# Service-Information Motorcycle

Group: Group 33  
Rear Wheel  
Drive

January 1992  
33 017 92  
(2506)

## Rear Shock Adjustment Knob Numbering - R100GS 1991 Models

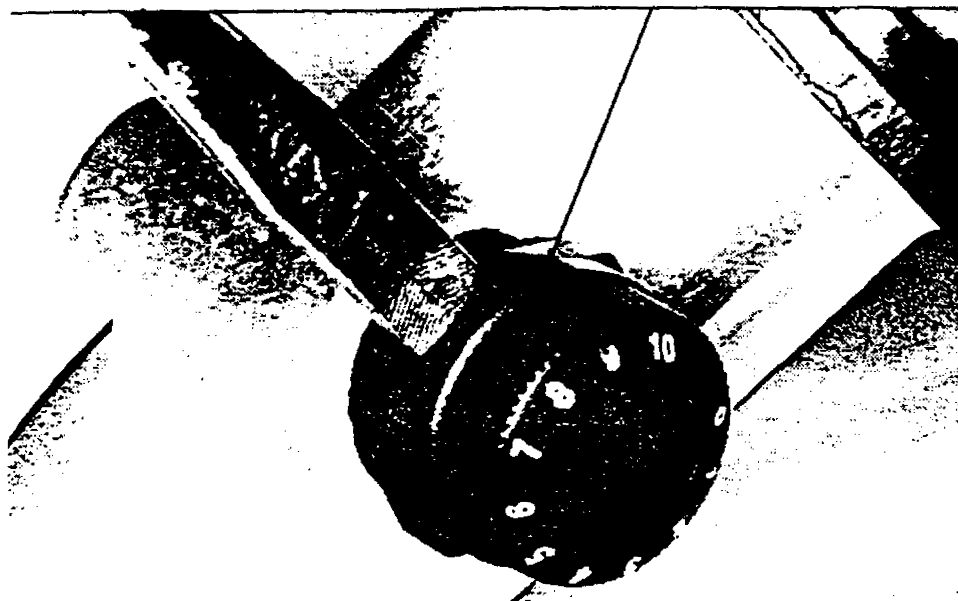
**Complaint:** The white numbers on the rear shock adjusting knob have a tendency to come off.

**Remedy:** Future adjusting knobs will have raised numbers. Replace the adjusting knob with:

Part No. 33 53 2 314 139

- Instructions:**
- Turn the knob to the maximum (position 10)
  - Using a center punch, put a mark on the plastic nut which is below the knob
  - Pry the knob off gently, using a screwdriver
  - Using a plastic hammer, drive the new adjusting knob on with the Figure 10 aligned with your center punch mark:
